Model	Model Code	Model Type
BF250A	BBJJ

Authorized by MATSUMURA HIROYUKI
Power Product Service Engineering Department, Honda Motor Co.,Ltd

Salt Accumulation

Countermeasure 1

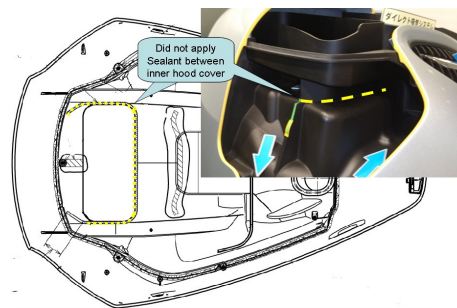
Due to lack of water proof sealant on inner cover, Inner cover sealant did not perform then water leaked to inside of engine.

Apply sealant on inner hood cover.(factory forgot to apply sealant)

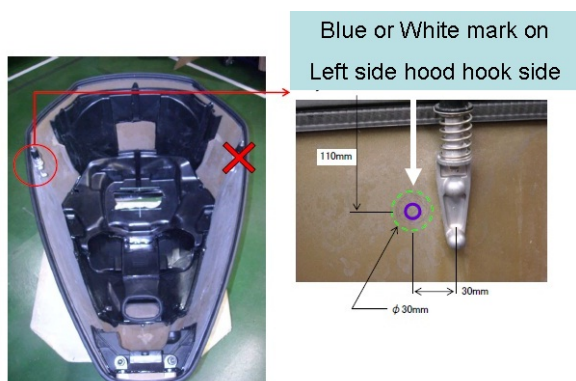
Apply sealant 2 times on inner cover for water proof performance up.

Countermeasure engine hood cover indicated paint mark as following area,

Please conduct engine appearance check during initial 20 hours or 100 hours regular service period at dealer. In case of there is any salt deposit or in case of customer is using outboard engine on heavy ocean waves area, please replace to C/M engine hood cover after cleaning the engine.
